RE: Charles Larsen Memorial Power Plant
Revised Draft Title V Permit No. 1050003-004-AV
Facility ID No. 105003; Polk County
Supplemental Information

RE: Lakeland Electric and Water Utilities
Charles Larsen Memorial Power Plant
Draft Title V Permit No. 1050003-004-AV
Facility ID No. 105003; Polk County
Supplemental Comments

Follow-Up Comments on Draft Title V Permit (February 7, 1997)

ATTACHMENT LR-EU3-C5
OPERATING CAPACITY COMMENT

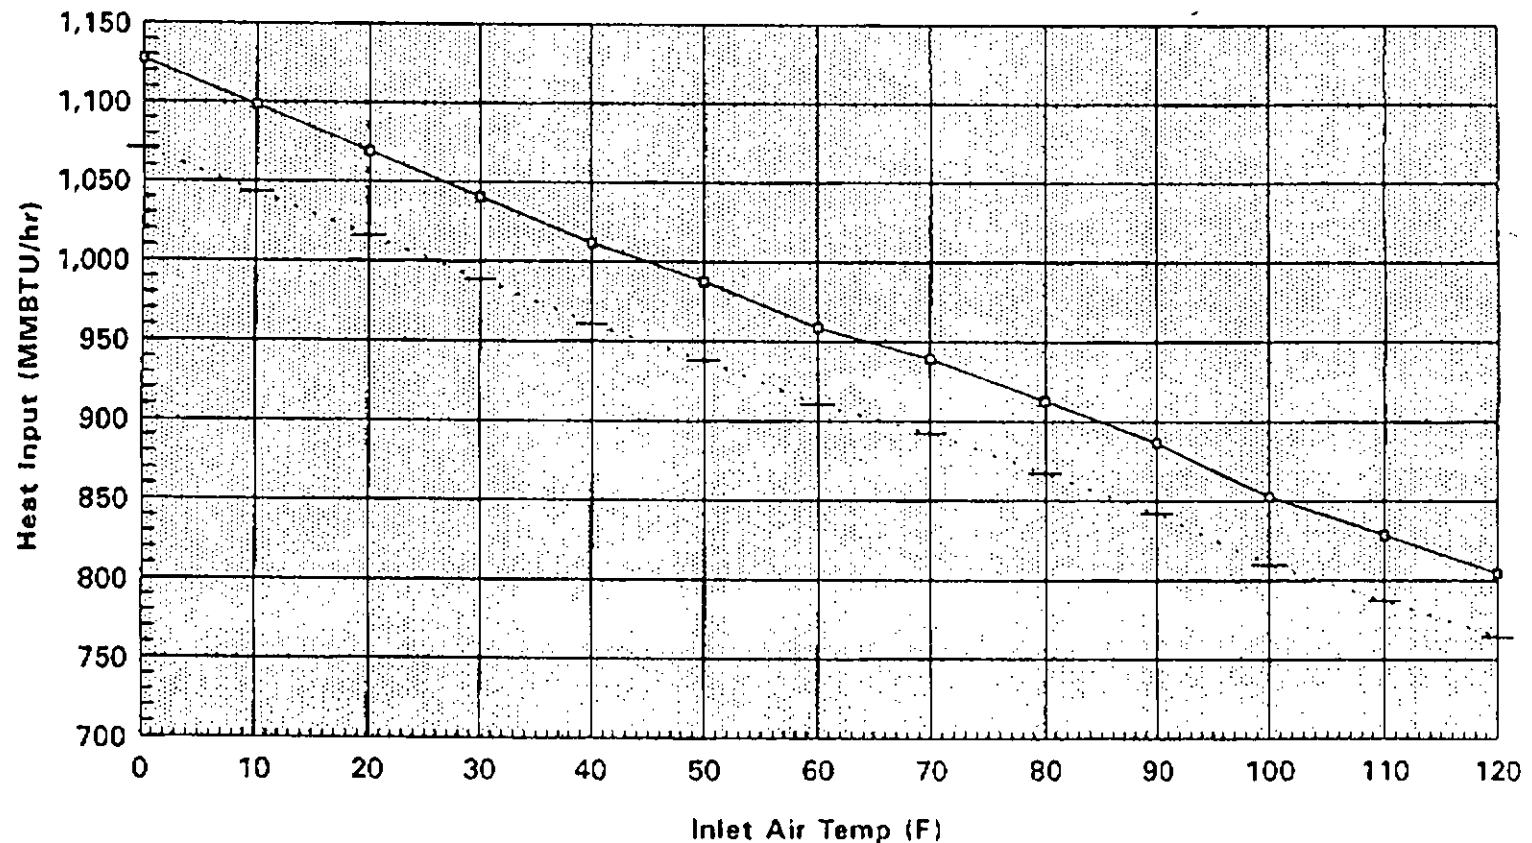
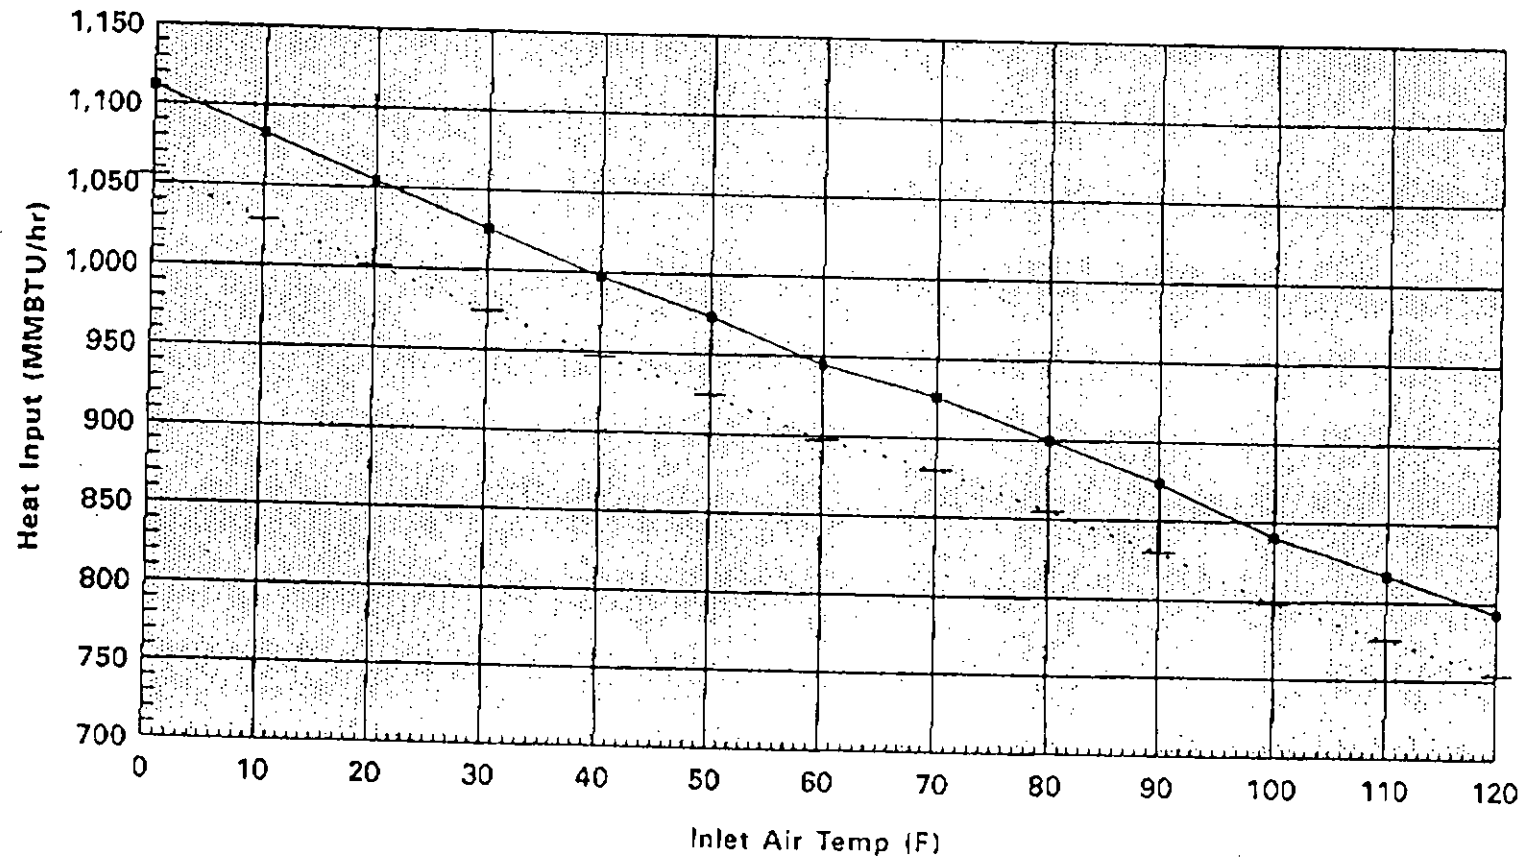
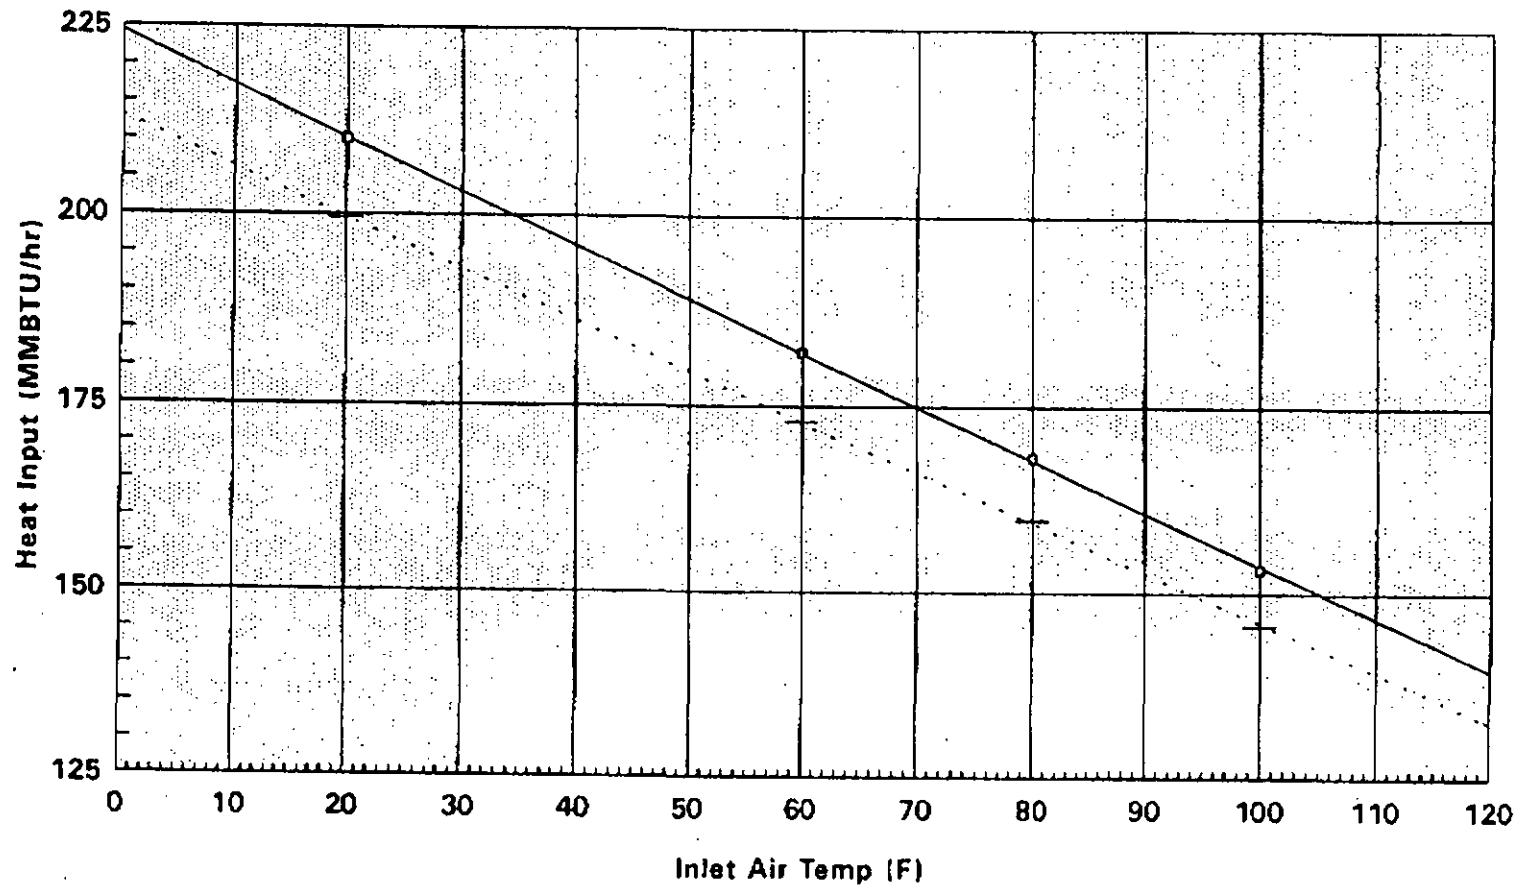
- The initial compliance testing on Unit No. 8 was performed August 3-7, 1992.
- The correct "Frequency Base Date" for Unit Nos. 6 and 7 is July 1 (see attached Notice of Permit Amendment" dated April 19, 1996).
- Condition C.1. for the three smaller combustion turbines should reflect an inlet temperature of 20 degrees F while firing oil and 25 degrees F while firing natural gas (as shown on the attached curves). In addition, the heat input rates should indicate that the basis is "lower heating value" fuel.
- Condition D.1. for Unit No. 8 should reflect a temperature of 25 degrees F for both oil and natural gas (as shown on the attached curves).

Maximum heat input based on LHV for natural gas at 25°F compressor inlet temperature. Heat input for residual oil heat input is 1,040 MMBtu/hr (LHV) at 25°F. Heat input as a function of compressor inlet temperature is attached as part of LR-EU3-C5.

**ATTACHMENT LR-EU4-C5
OPERATING CAPACITY COMMENT**

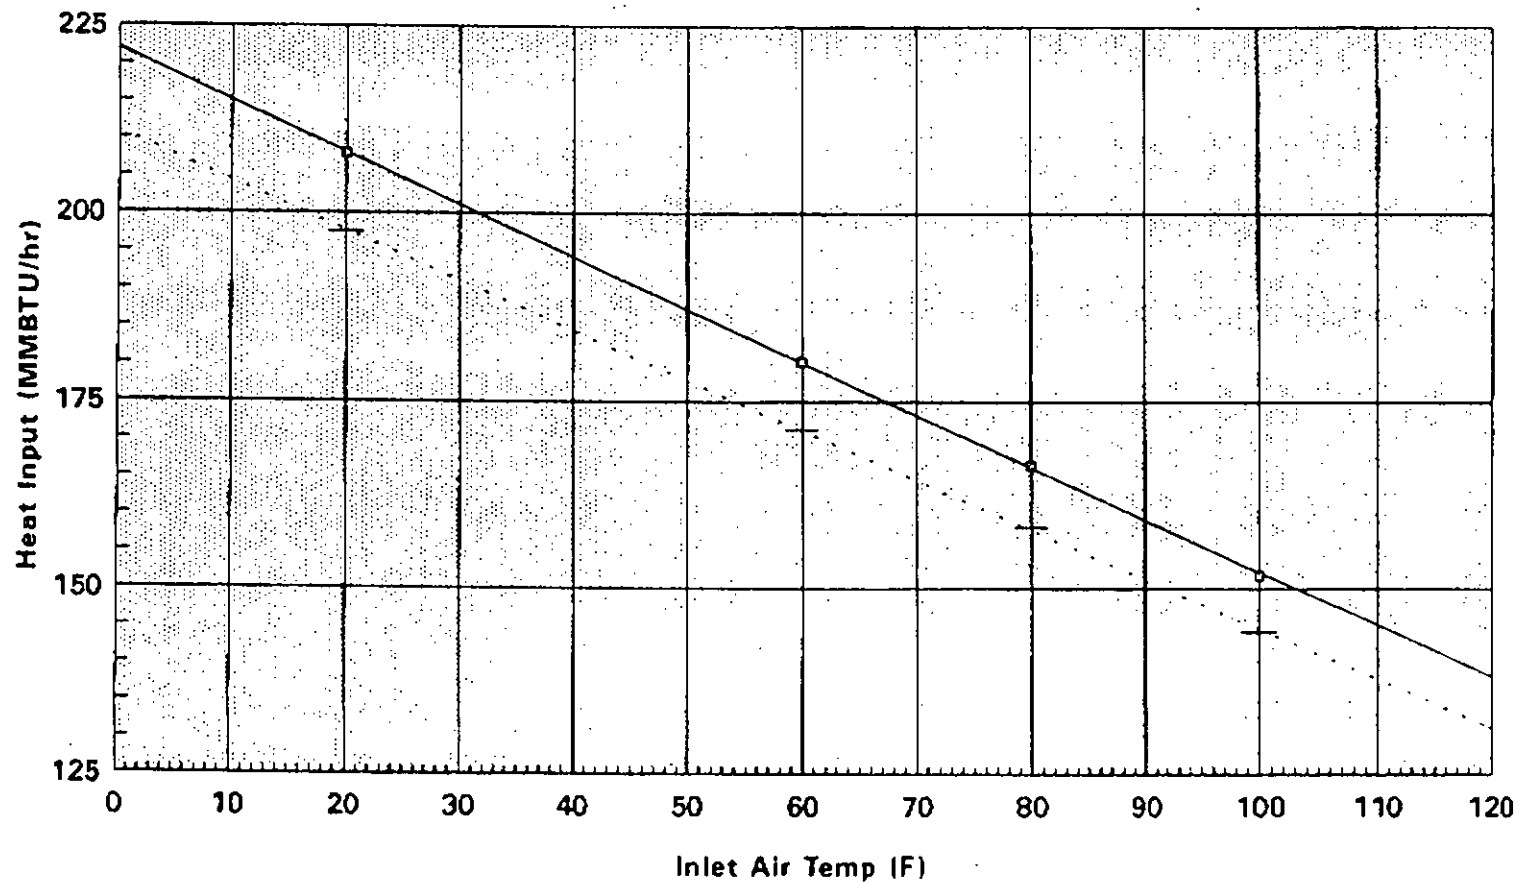
20. *Compliance Testing on Peaking Units*--While the current permit for Emission Units 005, 006, and 007 requires that compliance testing be conducted while the units operate at 90 to 100 percent of the maximum permitted heat input rate and does not mention the use of heat input curves based on ambient conditions, Lakeland has considered the Department's suggested language in the draft permit and agrees that it would be appropriate to use heat input curves. The permit application form is being revised with a new page 20 for these emissions units to address heat input and the use of heat input curves (included as part of Attachment B to the cover letter).

MW rating is 34.5 MW for 3 turbines (11.5 MW each). Maximum heat input [low heating value (LHV)] shown for both distillate oil and natural gas for each gas turbine at 30°F compressor inlet temperature. Heat input as a function of compressor inlet temperature is attached as part of LR-EU4-C5.
